Remarks

The Office Action mailed December 29, 2004, has been received and reviewed. Claims 1 through 48 are currently pending in the application. Claims 10 through 15 are objected to. Claims 1 through 9 and 16 through 48 have been allowed.

ANNOTATED SHEET SHOWING
CHANGES

Serial No.: 09/943,968

Fig. 9

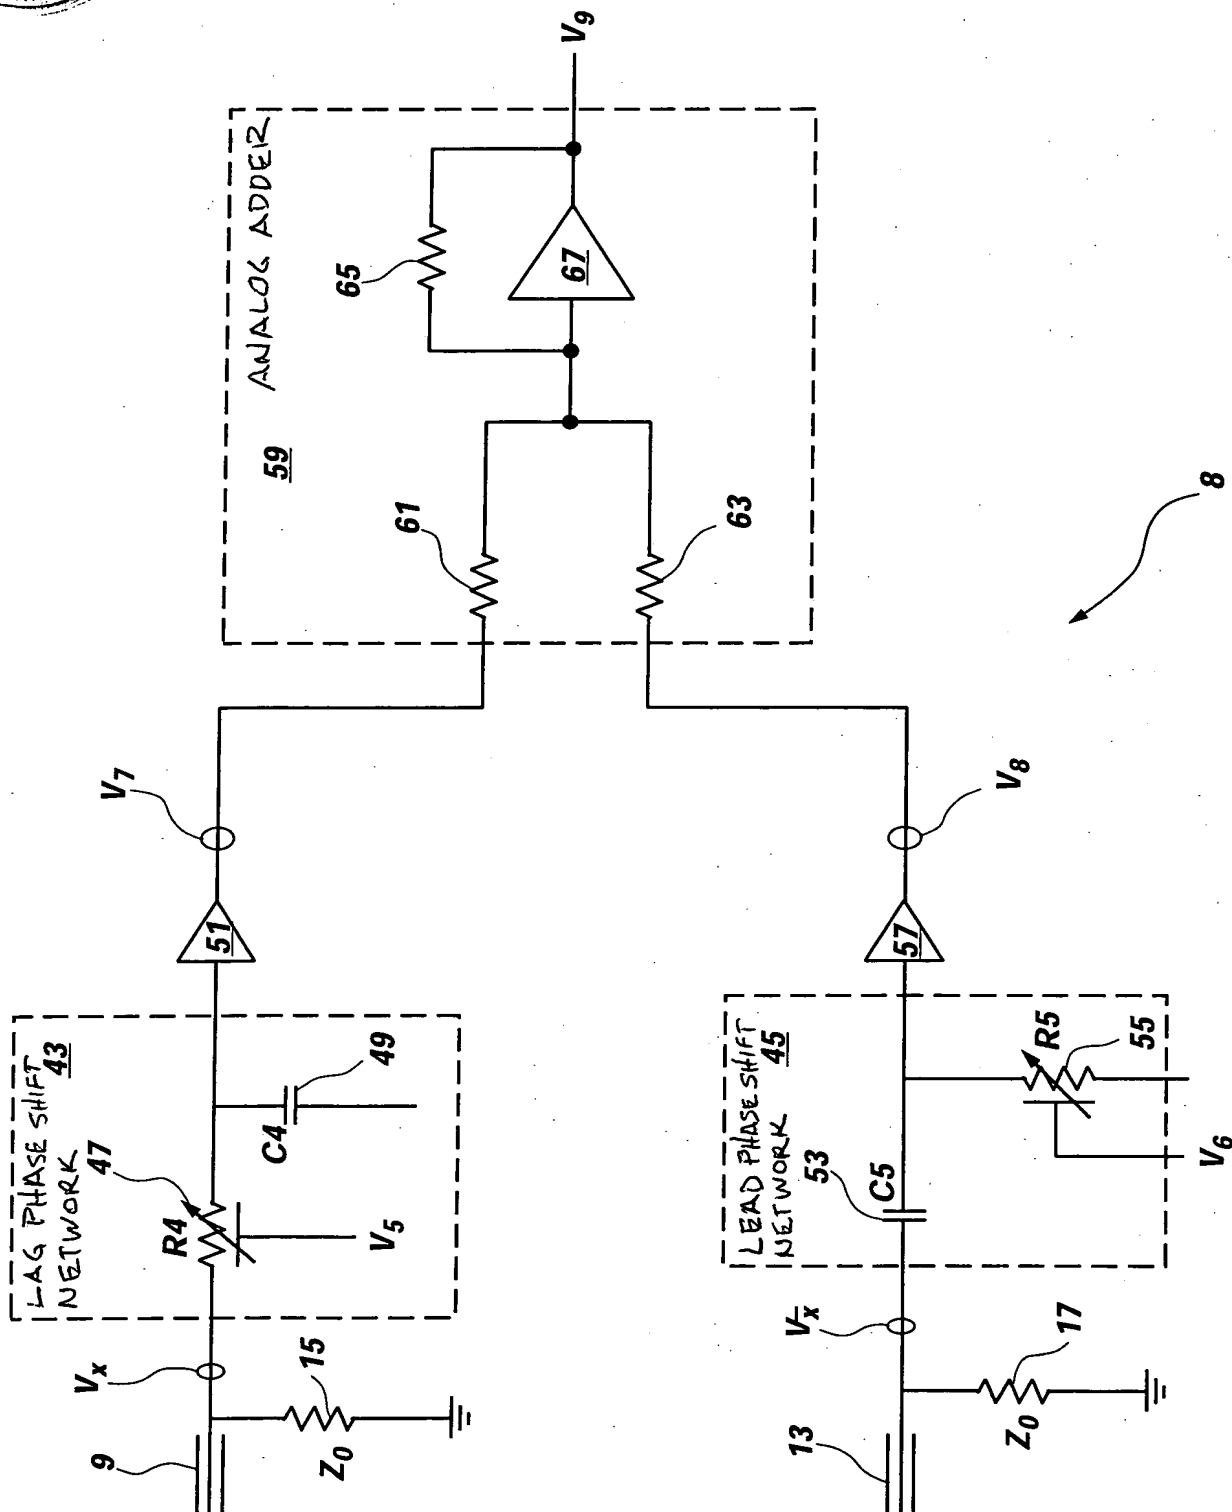
The attached replacement drawing sheet includes changes to FIG. 9. FIG. 9 has been amended to include a descriptive label for block elements 43, 45, and 59, as requested by the Examiner. Also attached, for the Examiner's convenience, is an annotated drawing sheet showing the changes incorporated into the replacement drawing sheet.
